STATE OF DELAWARE  
**DEPARTMENT OF TRANSPORTATION**  
800 BAY ROAD  
P.O. BOX 778  
DOVER, DELAWARE 19903

The enclosed Traffic Operational Analysis (TOA) review letter for the **Northstar** (Tax Parcel: 334-5.00-175.00) mixed use development has been completed under the responsible charge of a registered professional engineer whose firm is authorized to work in the State of Delaware. They have found the TOA to conform to DelDOT's Development Coordination Manual and other accepted practices and procedures for such studies. DelDOT accepts this letter and concurs with the recommendations. If you have any questions concerning this letter or the enclosed review letter, please contact me at [Annamaria.Furmato@delaware.gov](mailto:Annamaria.Furmato@delaware.gov).

RE: Agreement No. 2139S  
Traffic Impact Study Services  
**Task No. 2 Subtask 1 – Northstar**

McCormick Taylor has completed the Traffic Operational Analysis (TOA) for the proposed Northstar development. McCormick Taylor prepared the report in a manner generally consistent with DelDOT's Development Coordination Manual.

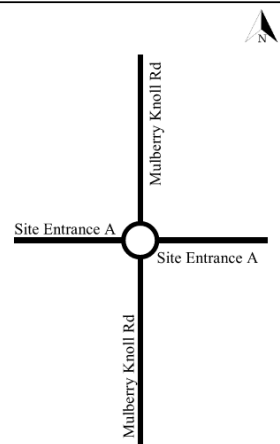
3. The developer should design and construct a roundabout on Beaver Dam Road at the intersection with the Mulberry Knoll Road Extension (road to be constructed by the developer as described in Item No. 2 above). The roundabout should be constructed with the footprint of a multilane roundabout, but it would initially function as a single-lane roundabout. The proposed configuration is shown in the table below.

Marked crossings should be provided on all approaches to the roundabout.

It is anticipated that this single-lane roundabout will later function as a multilane roundabout when DelDOT's *Beaver Dam Road Widening – SR 1 to Dairy Farm Road* project is constructed. At that time, the Beaver Dam Road approaches will each enter the roundabout with two lanes while the Mulberry Knoll Road approaches will continue to enter the roundabout with one lane. As such, the initial roundabout design and construction must account for the future Beaver Dam Road widening and must be set up to facilitate, as easily as possible, a change to multilane roundabout operations. The developer should coordinate with DelDOT's Development Coordination Section to determine design details during the site plan review. The developer will be credited against their TID fee for this work.

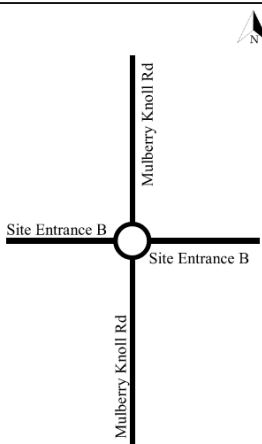
4. The developer should design and construct a single-lane roundabout at proposed Site Entrance A on the future Mulberry Knoll Road Extension. Site Entrance A should be located approximately 500 feet south of US Route 9. The proposed configuration is shown in the table below.

Marked crossings should be provided on all approaches to the roundabout.

The developer should coordinate with DelDOT's Development Coordination Section to determine design details during the site plan review.

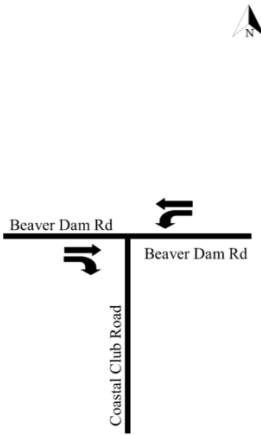
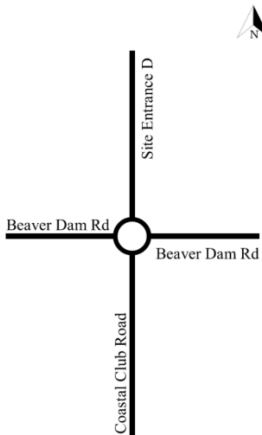
5. The developer should design and construct a single-lane roundabout at proposed Site Entrance B on the future Mulberry Knoll Road Extension. Site Entrance B should be located approximately 600 feet north of Beaver Dam Road. The proposed configuration is shown in the table below.

Marked crossings should be provided on all approaches to the roundabout.

The developer should coordinate with DelDOT's Development Coordination Section to determine design details during the site plan review.

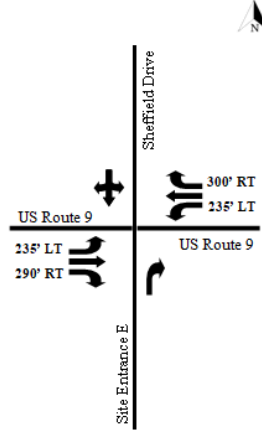
6. The developer should design and construct the full-movement Site Entrance C on the future Mulberry Knoll Road Extension. Site Entrance C should be located at least 500 feet south of Beaver Dam Road. The proposed configuration is shown in the table below.

At the proposed Site Entrance C intersection, a southbound left-turn lane and a northbound right-turn lane are each warranted on the Mulberry Knoll Road Extension based on DelDOT's Auxiliary Lane Worksheet. Initial recommended minimum turn lane lengths (excluding taper) are: 160-foot southbound left-turn lane and 145-foot northbound right-turn lane on Mulberry Knoll Road Extension. The westbound right-turn lane on the Site Entrance C approach to the Mulberry Knoll Road Extension should be 50-foot long (excluding taper). The developer should coordinate with DelDOT's Development Coordination Section to determine final turn lane lengths and other design details during the site plan review.

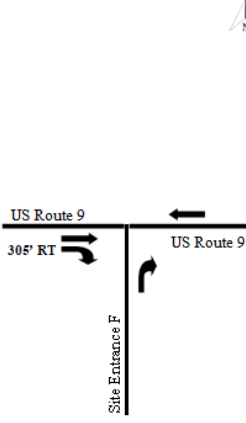
7. The developer should design and construct Site Entrance D on Beaver Dam Road across from Coastal Club Road by converting the existing three-leg intersection to a four-leg roundabout. The roundabout should be constructed with the footprint of a multilane roundabout, but it would initially function as a single-lane roundabout. The proposed configuration is shown in the table below.

Marked crossings should be provided on all approaches to the roundabout.

It is anticipated that this single-lane roundabout will later function as a multilane roundabout when DelDOT's *Beaver Dam Road Widening – SR 1 to Dairy Farm Road* project is constructed. At that time, the Beaver Dam Road approaches will each enter the roundabout with two lanes while the Coastal Club Road and Site Entrance D approaches will continue to enter the roundabout with one lane. As such, the initial roundabout design and construction must account for the future Beaver Dam Road widening and must be set up to facilitate, as easily as possible, a change to multilane roundabout operations. After the developer has exhausted all efforts to acquire the necessary right-of-way to construct this roundabout, if they are unable to acquire the right-of-way, then DelDOT may assist the developer with condemnation. The developer should coordinate with DelDOT's Development Coordination Section to determine design details during the site plan review. This roundabout, to be constructed by the developer, is considered to be a TID improvement and the developer will be partially credited against their TID fee for the part within the DelDOT right-of-way. Improvement costs that are creditable include the additional cost of this roundabout that exceeds the cost of a traffic signal in this location. The cost of the site entrance connecting to this roundabout is not creditable.

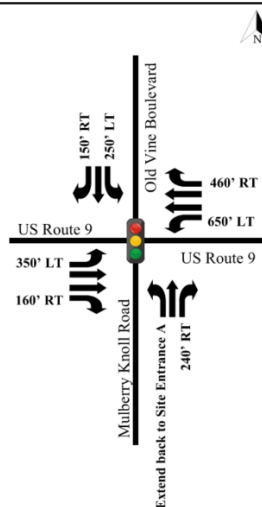
8. The developer should design and construct the right-in/right-out/left-in Site Entrance E on the US Route 9 across from Sheffield Drive. The proposed configuration is shown in the table below.

At the proposed Site Entrance E intersection on US Route 9 opposite Sheffield Drive, separate left-turn and right-turn lanes are warranted on the eastbound and westbound US Route 9 approaches based on DelDOT's Auxiliary Lane Worksheet. Initial recommended minimum turn lane lengths (excluding taper) are: 235-foot eastbound left-turn lane, 290-foot eastbound right-turn lane, 235-foot westbound left-turn lane, and 300-foot westbound right-turn lane on US Route 9. Note that the length of the existing westbound right-turn lane exceeds 300 feet so it does not need to be lengthened. Signage and physical measures such as a channelization island should be included at the Site Entrance E intersection with US Route 9 to restrict prohibited northbound left turns leaving the site via Site Entrance E. The developer should coordinate with DelDOT's Development Coordination Section to determine final turn lane lengths and other design details during the site plan review.
